TEXAS UTILITIES GENERATING
COMPANY, et al.

(Comanche Peak Steam Electric Station
Station, Units 1 and 2)

CASE'S PARTIAL ANSWER TO APPLICANTS' STATEMENT OF MATERIAL FACTS AS TO WHICH
THERE IS NO GENUINE ISSUE REGARDING ALLEGATIONS CONCERNING
CONSIDERATION OF FORCE DISTRIBUTION IN AXIAL RESTRAINTS

AFFIDAVIT OF CASE WITNESS MARK WALSH

Filing Code _____
 Sheet No. 1 of 2
 G & H Job No. _____

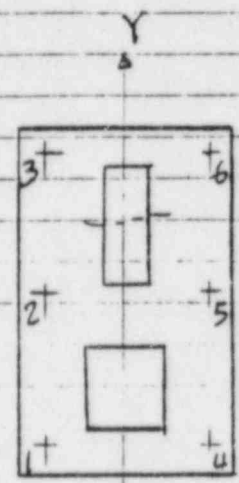
See answer 4 above. In addition, on August 22, the Applicants provided to CASE on discovery (requested 8/1/84 /6/) one pipe support drawing and partial calculations which, according to Applicants, included the maximum difference in loads with and without consideration of the rotational constraint (see Attachment C hereto). On page 1 of 2 of Attachment C, dated 6/14/84, near the middle of the page there is a Table. Above the Table there is a ratio of the old load vs. the new load. The ratio of 1.459 which is shown in the top portion of the calculation is apparently in error. The load due to the moment restraint of the pipe is listed as 142 kips. The original load divided by 2 (for one of the stanchions) is shown to be 97.329 kips. The ratio should be $142 \text{ plus } 97.329 \text{ divided by } 97.329 = 2.45$, a considerable difference.

In the Table, under Bolt Tension, the new load appears to be obtained by multiplying the existing load by the ratio of 1.459. For example, bolt 6 had an existing tensile load of 26192.38 lbs. The new load is $26192.38 \text{ times } 1.459 = 38213.87 \text{ lbs.}$, as is shown in the table. But using the correct ratio of 2.45, the tensile load in bolt 6 is $26192.38 \text{ times } 2.45 = 64170. \text{ (rounded) lbs.}$

Under bolt shear for bolt 6, the existing load is 18657.21. The new load using Applicants' figures should be then, $18657.21 \text{ times } 1.459 = 27221. \text{ lbs.}$ (rounded off because I don't think including the 1/100 of a lb. will offset the 27,000 lbs. already calculated). But

apparently the Applicants have a new way of figuring their shear loads. They use a new method called "redistribution" (see fifth column of table). Not considering this "redistribution," the correct shear load would be 2.45 times 18657.21 = 45710. lbs. This is over three times greater than what the Applicants arrived at.

The insert allowable (shown at the bottom of the page, left), according to the Applicants' PSE Guidelines, is 25 kips for tension and 25 kips for shear (see CASE Exhibit 724, admitted at Tr. 6471, copy attached). The calculations do not show justification for Applicants' doubling the allowable shear load for the insert (as shown in Attachment C). It is apparent that the correct tensile load by itself will exceed the allowable.

The Applicants have also listed the allowable tensile and shear capacities of the A193 high strength bolt in the attachment as 90 kips in tension and 42.4 kips in shear. The Applicants have shown in their PSE Guidelines (CASE Exhibit 724) the allowable tensile capacity for an A193 bolt as 66 kips (working load), and in shear, the working load is 34.5 kips.
